Consent Agenda Item (Action Item): Consider/Approve Change Order No. 1 and Change Order No. 2 for the Betsy Layne High School (BLHS) Athletic Improvements Project

CHANGE ORDER

CO #: CO-002
PROJECT: 26004

SITE LAYOUT & DEVELOPMENT PLAN
Floyd County Athletics - Betsy Layne Synthetic Turf Replacement
for
Floyd County Board of Education
442 KY-550, Eastern, Kentucky, 41622

SD1.1

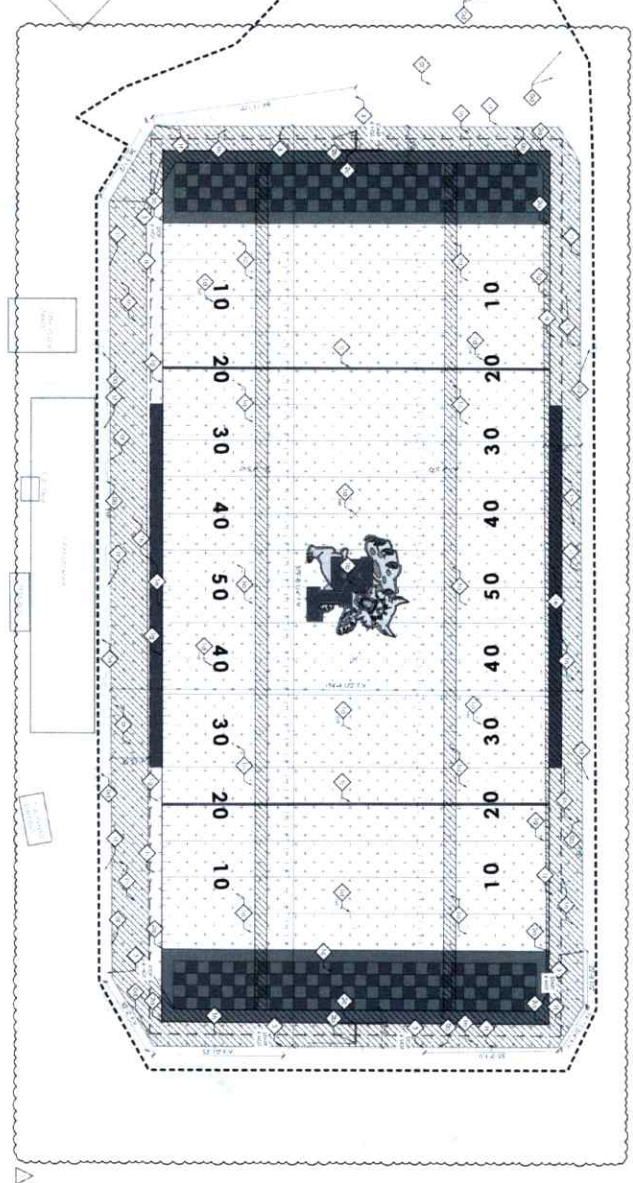
2. Option 2: Refer to sheet SD1.1 – Site Layout & Development Plan:
 - a. Remove 15'-0" of existing stone from the perimeter of the field as indicated and to a depth that allows for visual inspection of the existing panel drainage system and to the collector pipe system.

- b. Provide new drainage stone consisting of new #57 stone with a 1" layer of clean cap stone.
3. Option 2b: Refer to sheet SD1.1 – Site Layout & Development Plan:

- a. Remove 5'-0" of existing stone as indicated and to a depth that exposes the existing panel drainage system.
 - b. Provide new drainage stone consisting of new #57 stone with a 1" layer of clean cap stone.

DESCRIPTION OF WORK: a. Remove 15'-0" of existing stone from the perimeter of the field as indicated and to a depth that allows for visual inspection of the existing panel drainage system and to the collector pipe system.

b. Provide new drainage stone consisting of new #57 stone with a 1" layer of clean cap stone.

a. Remove 5'-0" of existing stone as indicated and to a depth that exposes the existing panel drainage system.

b. Provide new drainage stone consisting of new #57 stone with a 1" layer of clean cap stone.

SD1.1
 25-715
 1/2" = 1'-0"

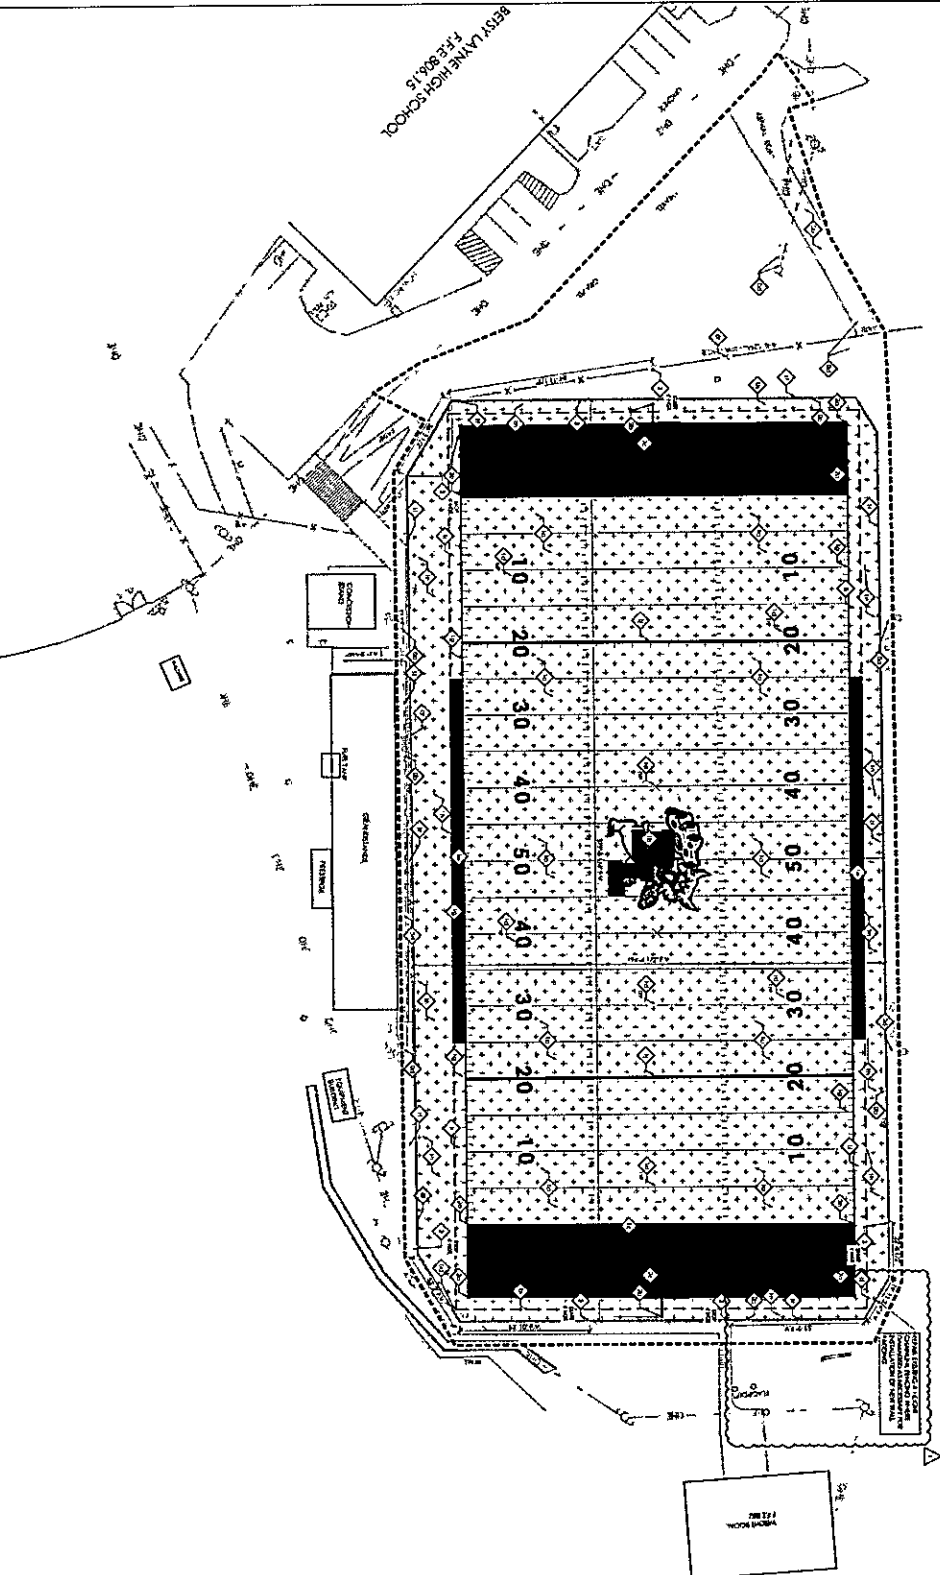
Repair chain link fencing as shown on SD1.1 as necessary for installation of new wall padding.

SITE LAYOUT & DEVELOPMENT PLAN
Floyd County Athletics - Betsy Layne Synthetic Turf Replacement
FOR
Floyd County Board of Education
442 KY-550, Eastern, Kentucky, 41622

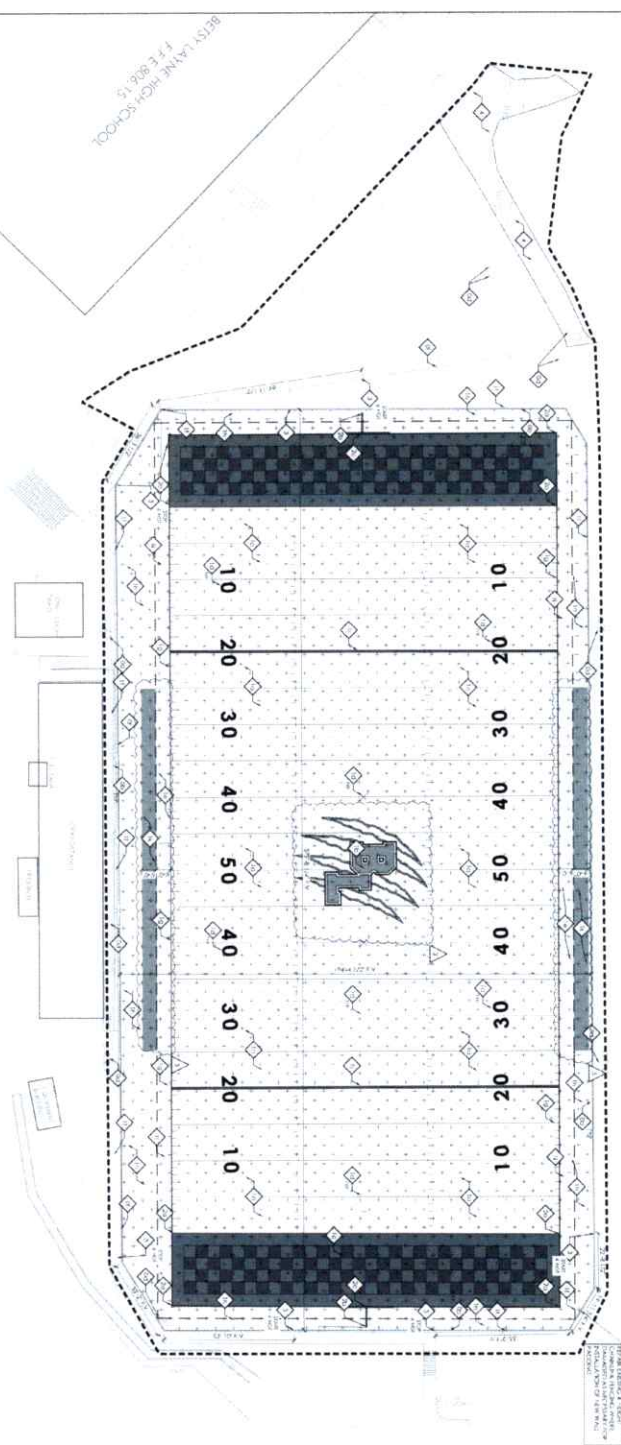
1. Refer to sheet SD1.1 – Site Layout & Development Plan:
 - a. Revise size and color of both coaches' boxes as shown on plan.
 - b. Add player's boxes as shown on plan.
 - c. Revise 50-yard logo as shown on plan.
2. Refer to sheet SD4.1 – Site Details:
 - a. Revise 50 yard logo as shown on detail A/SD4.1.
